CROWN STREET WOLLONGONG

RTS DESIGN RESPONSE
WOLLONGONG DEVELOPMENTS NO.8 PTY LTD

RtS DESIGN RESPONSE PURPOSE

AMENDED LOWER GROUND PLAN

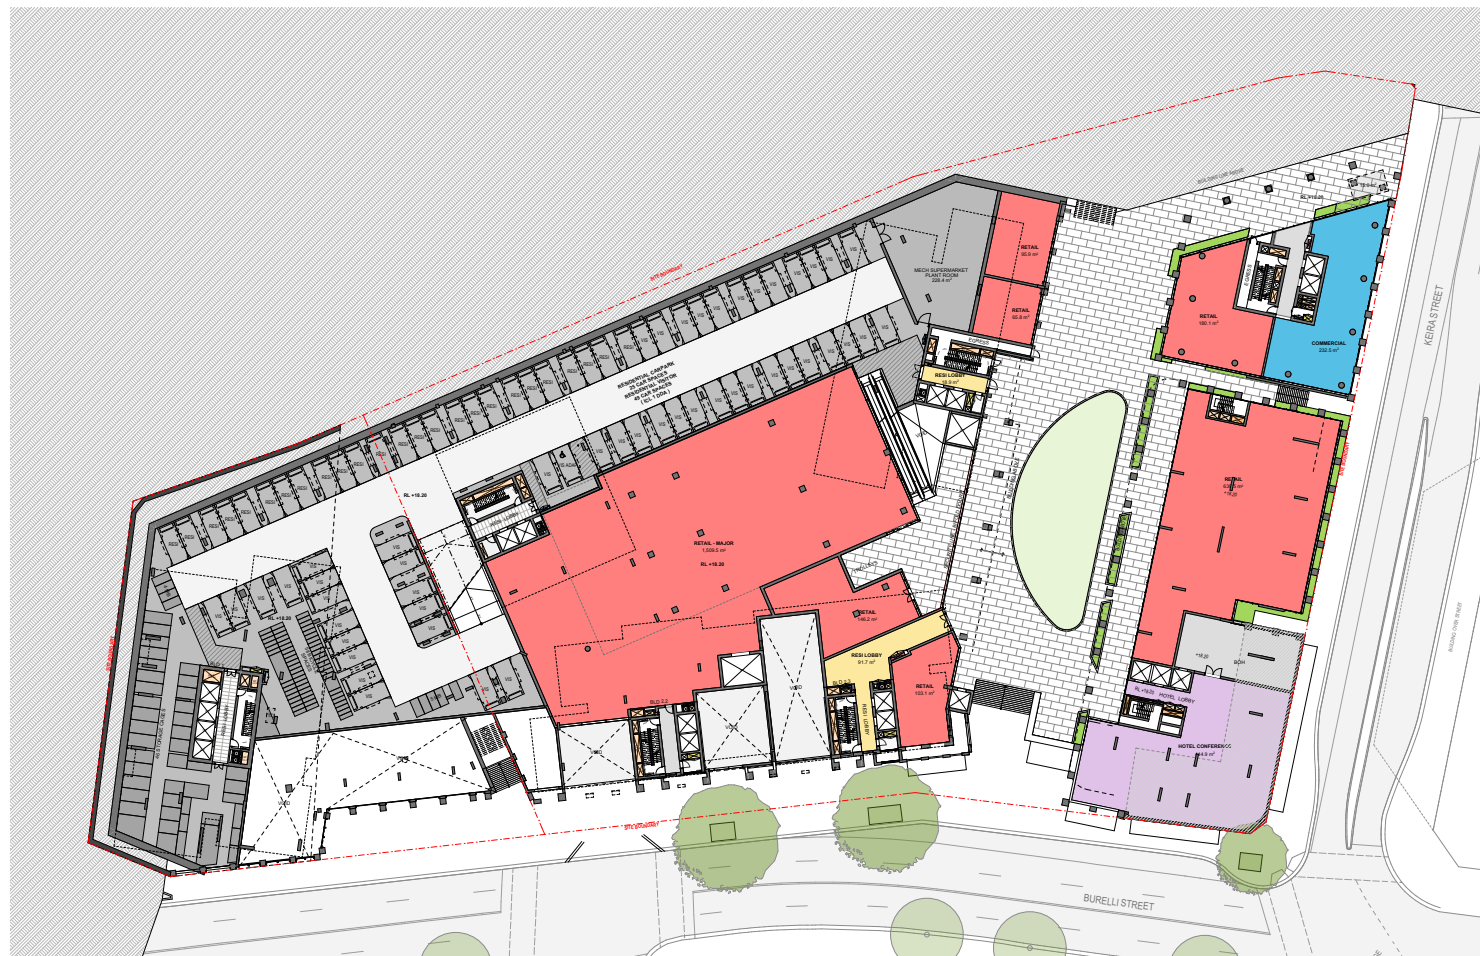
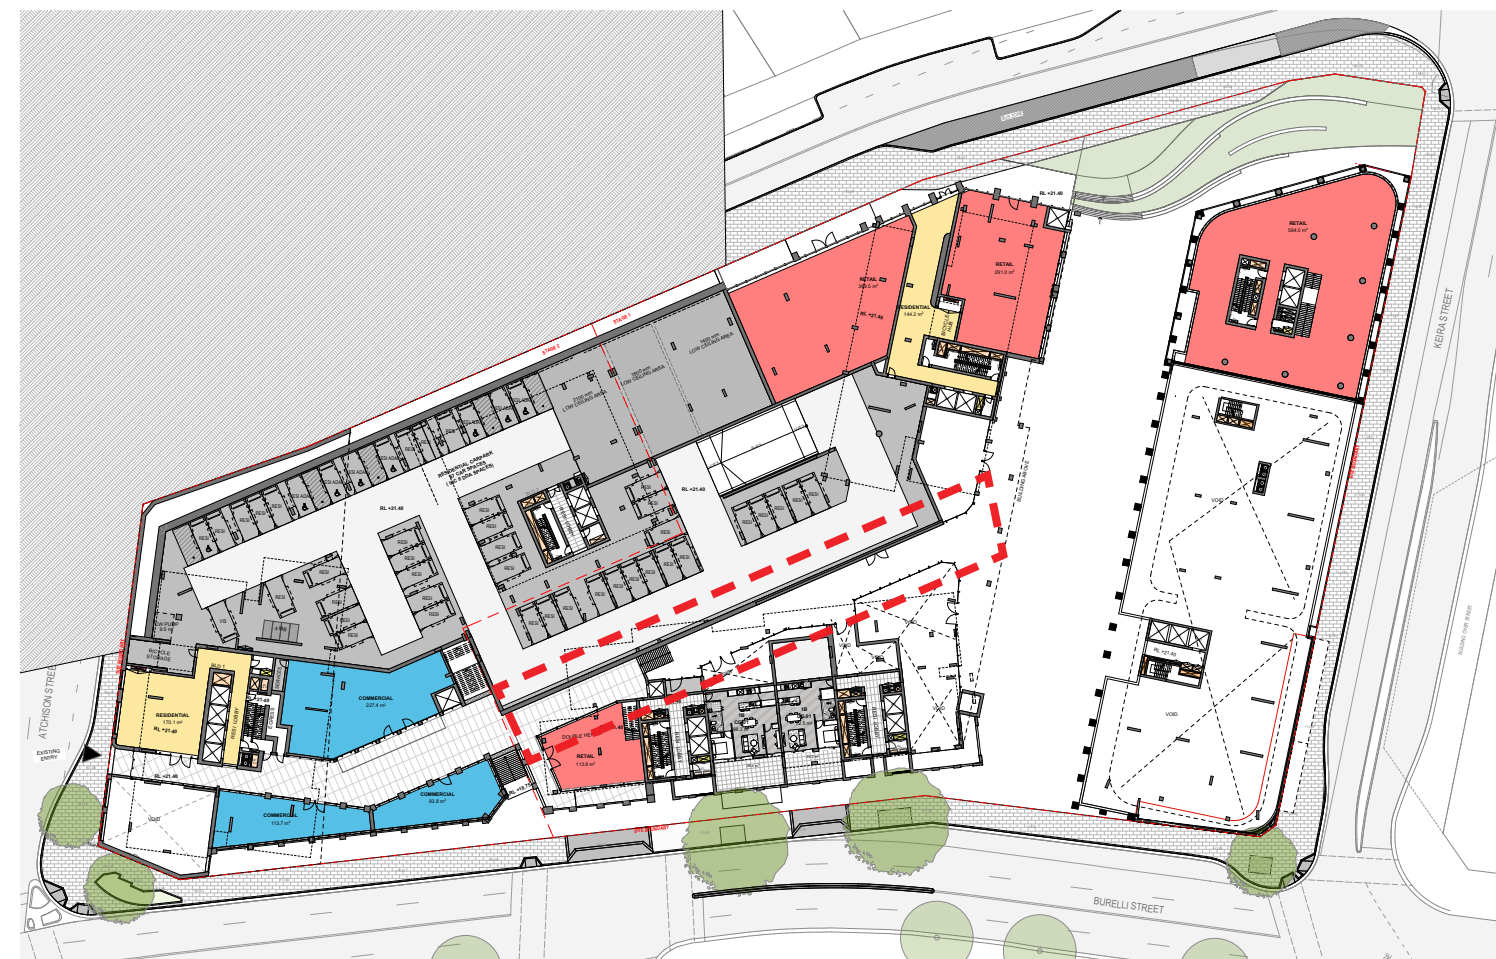
Consider options to enhance east-west permeability through the podium by providing a connection/additional entry from the supermarket to the western through site link, as well as a connection from the Marcus Clarke building's large retail tenancy to both the western lane way and Atchison Street.

Response
A new east-west through-site link has been incorporated into the plans to improve pedestrian permeability and connectivity across the site.

BASEMENT O1 LEVEL

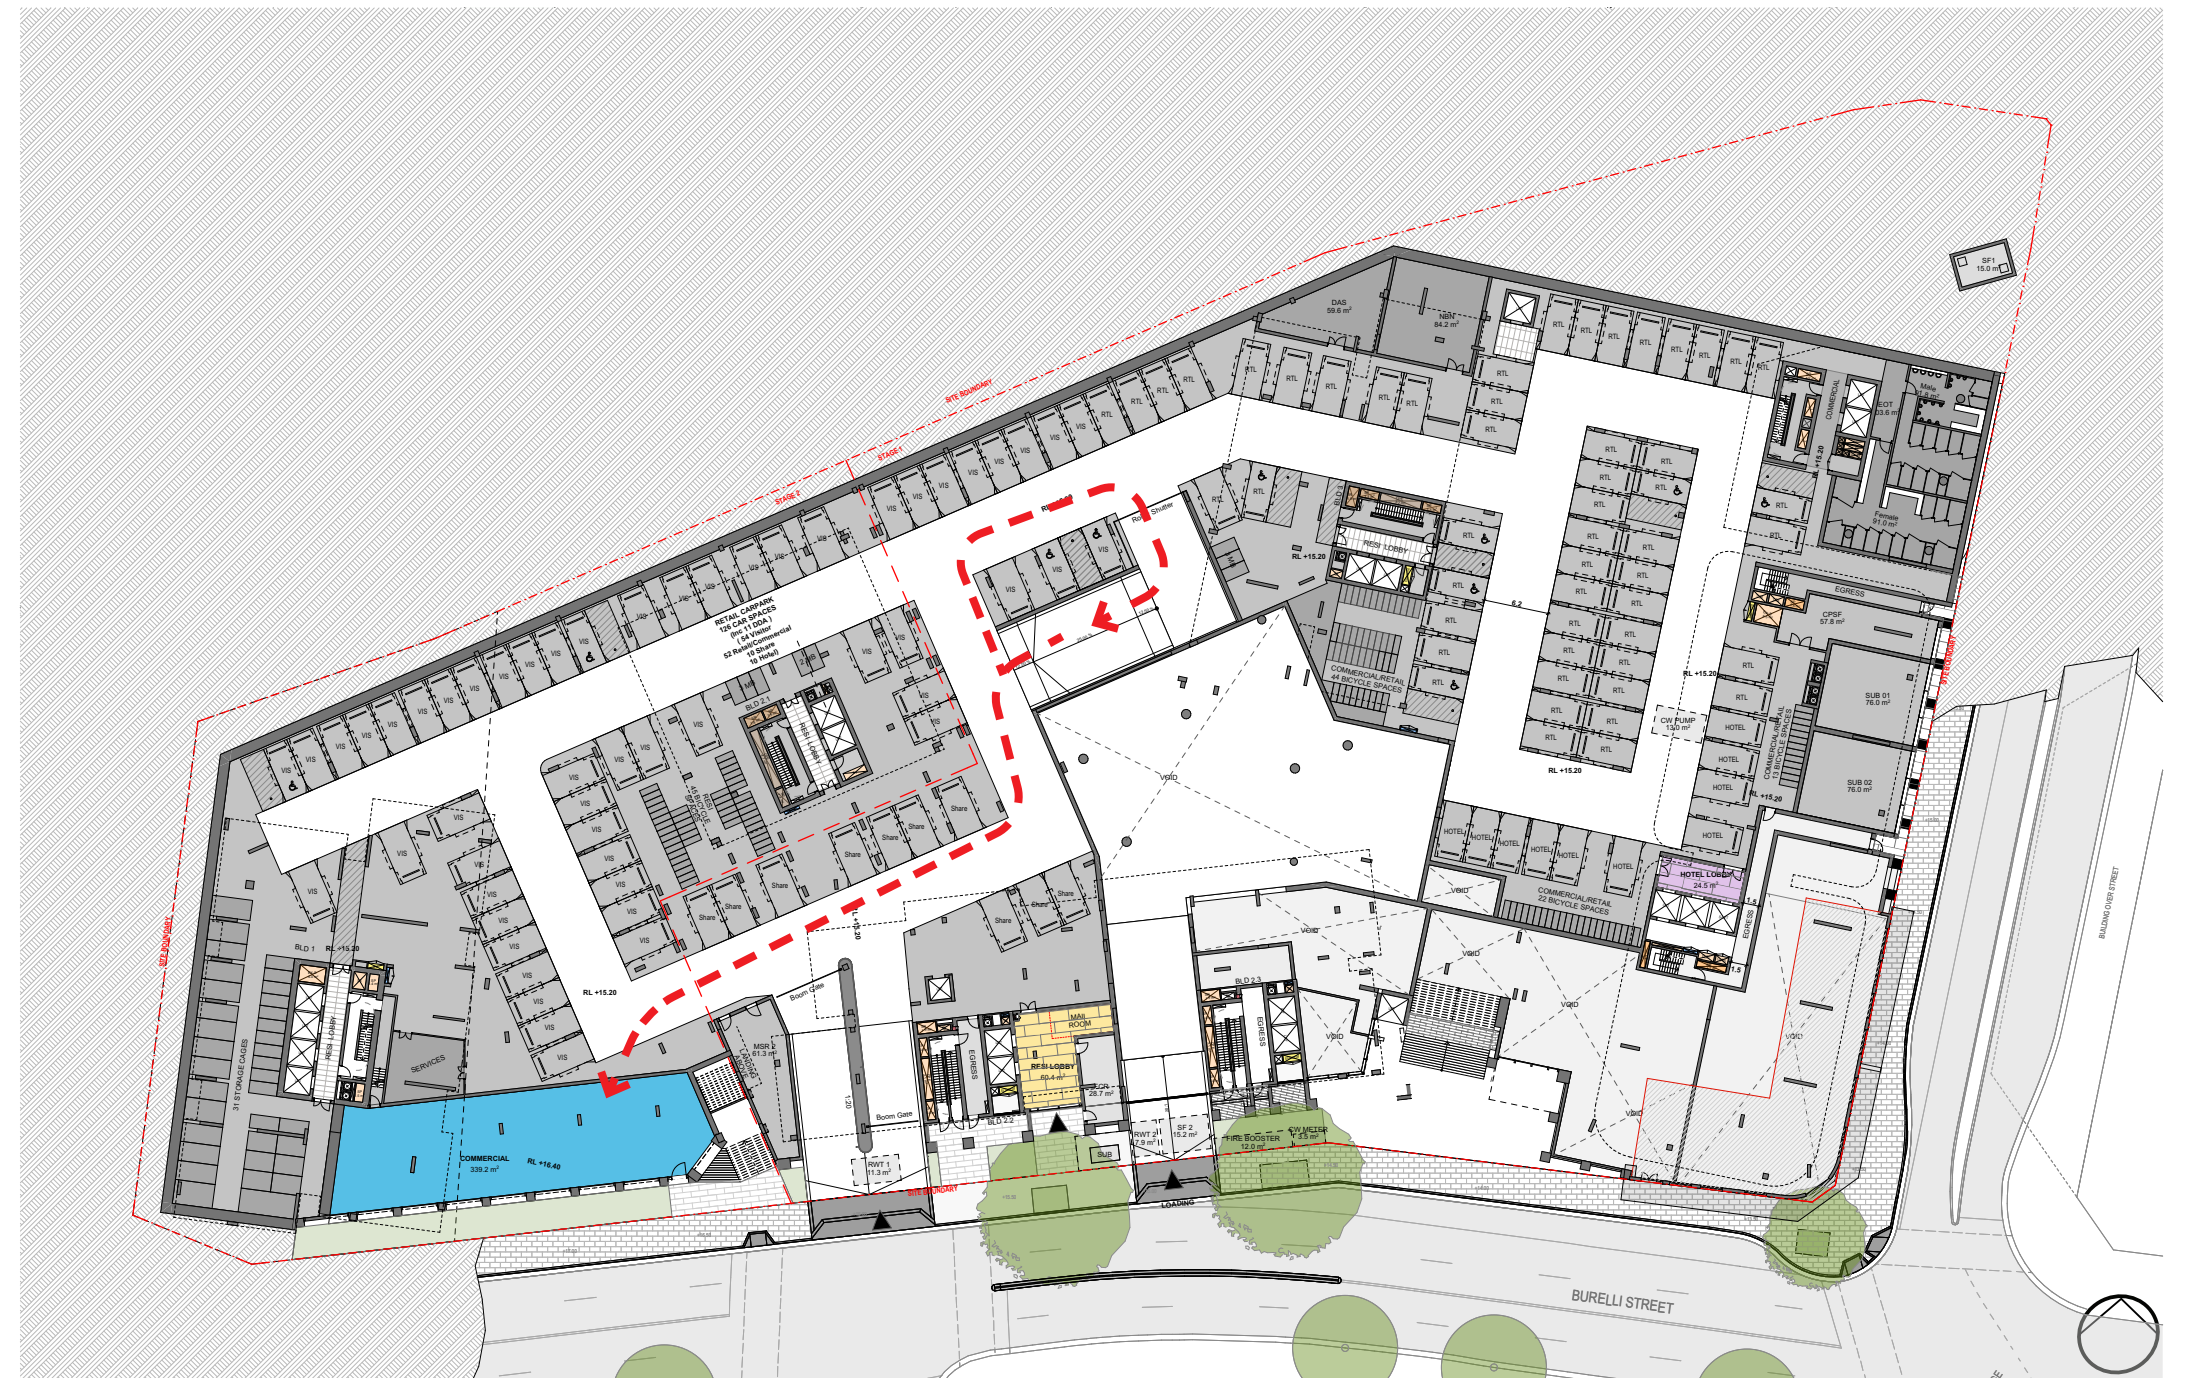
Detail delivery arrangements , including paths of travel from the loading dock to all retail, commercial, and hotel premises (without using residential lifts) and update the traffic assessment to reflect all delivery types, including hotel laundry and catering .

Paths of travel shown demonstrating paths of travel from loading through the basement.

Lower Ground level

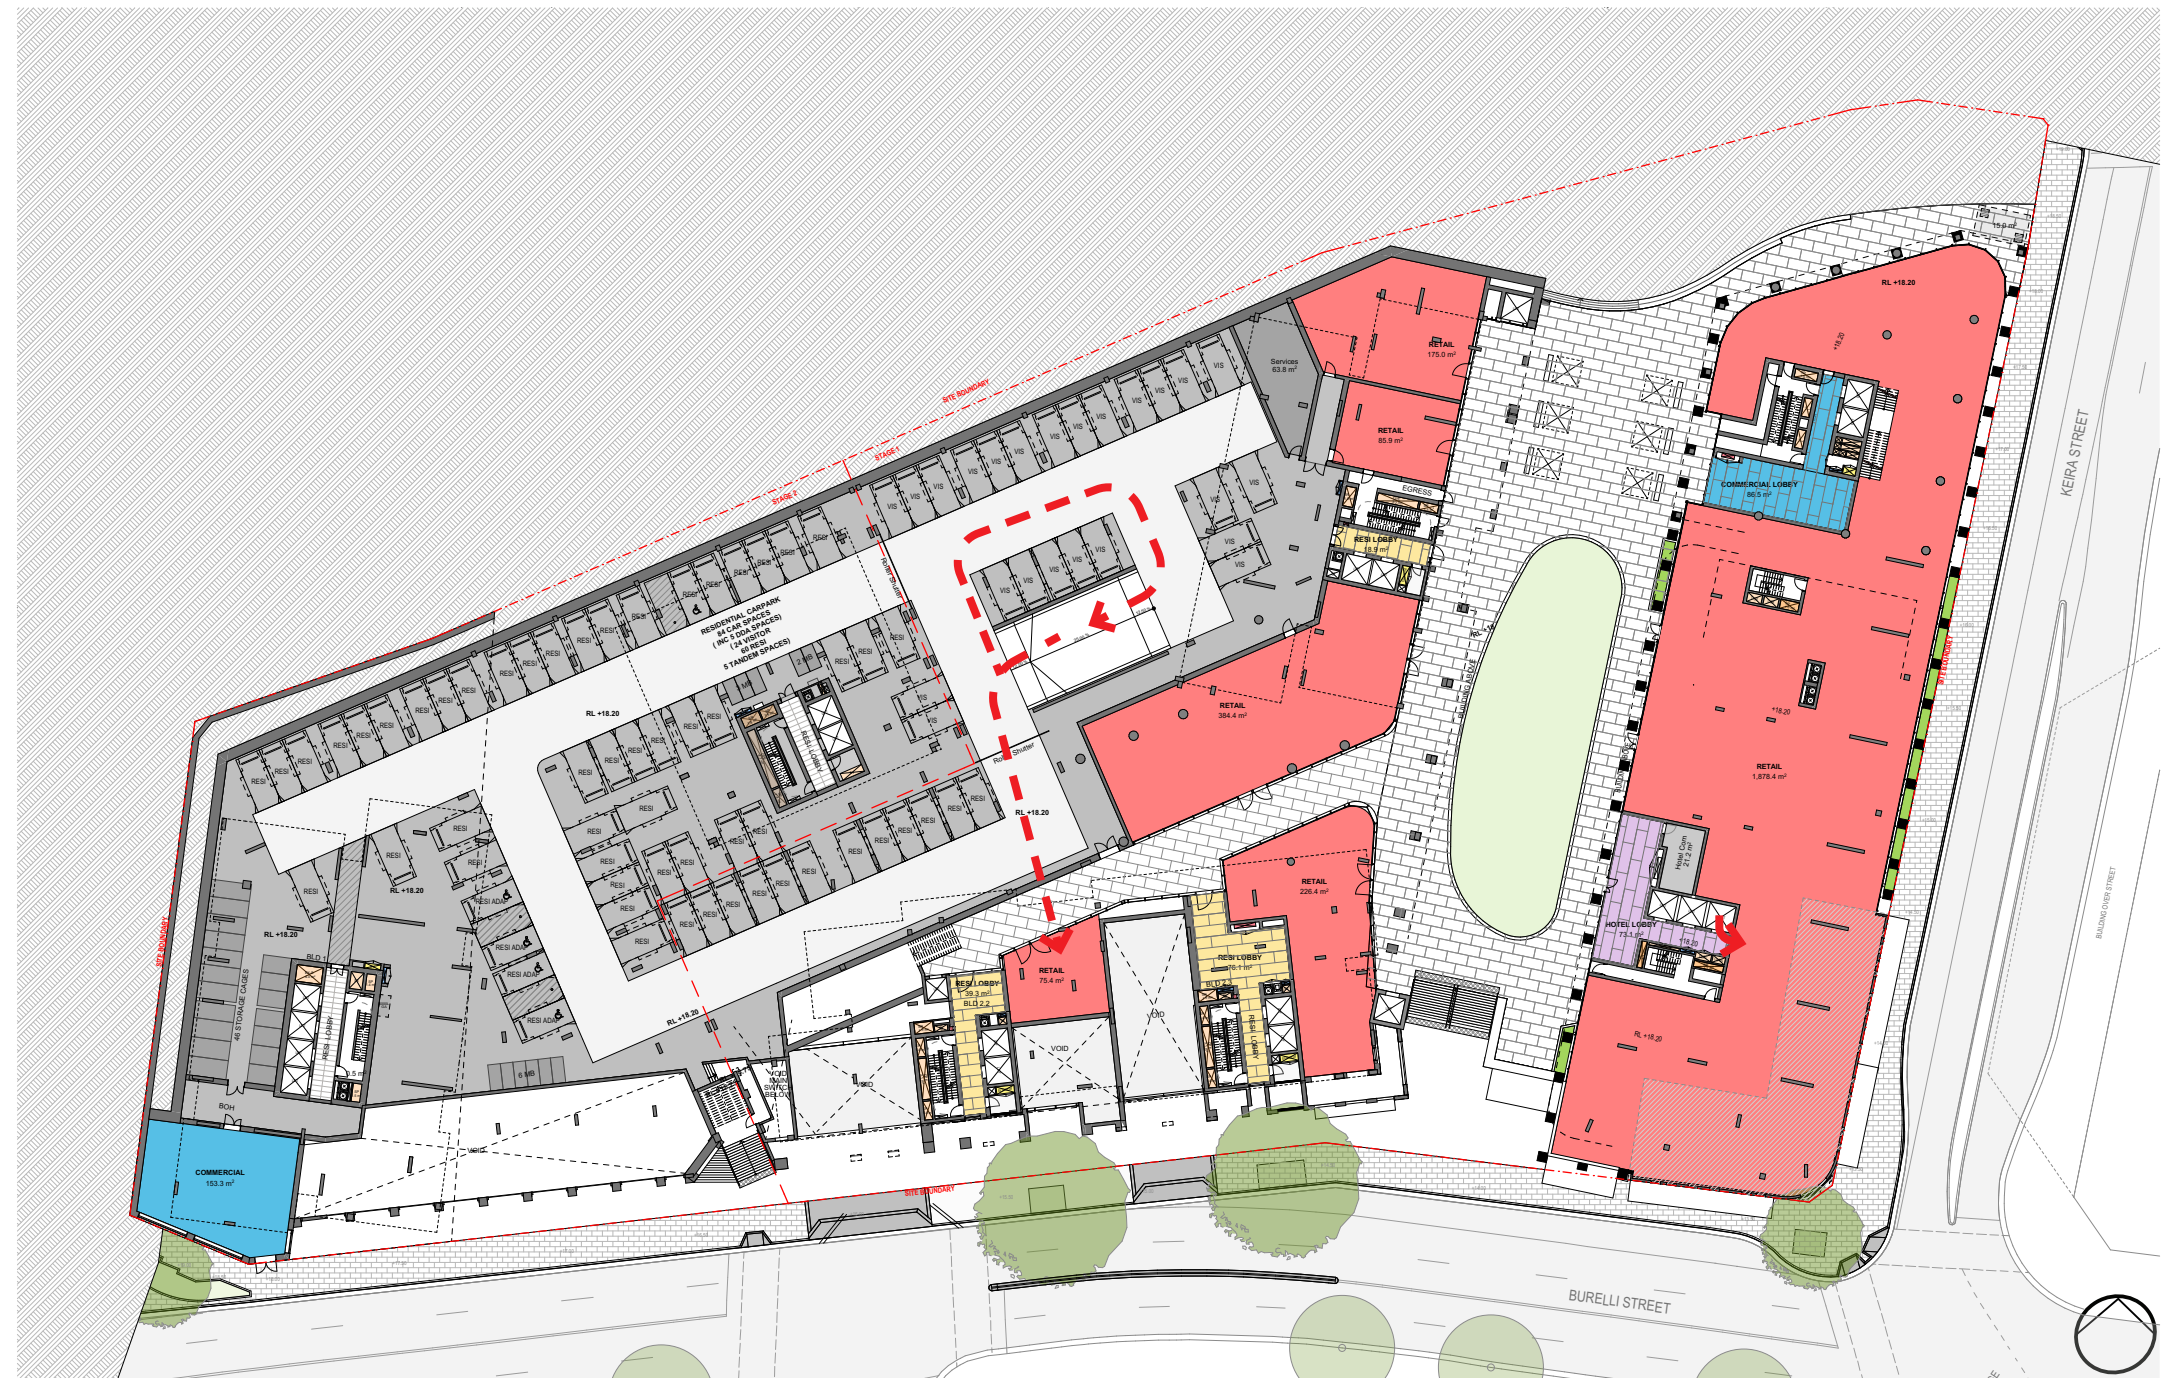
Detail delivery arrangements , including paths of travel from the loading dock to all retail, commercial, and hotel premises (without using residential lifts) and update the traffic assessment to reflect all delivery types, including hotel laundry and catering .

Paths of travel shown demonstrating paths of travel from loading through the basement.
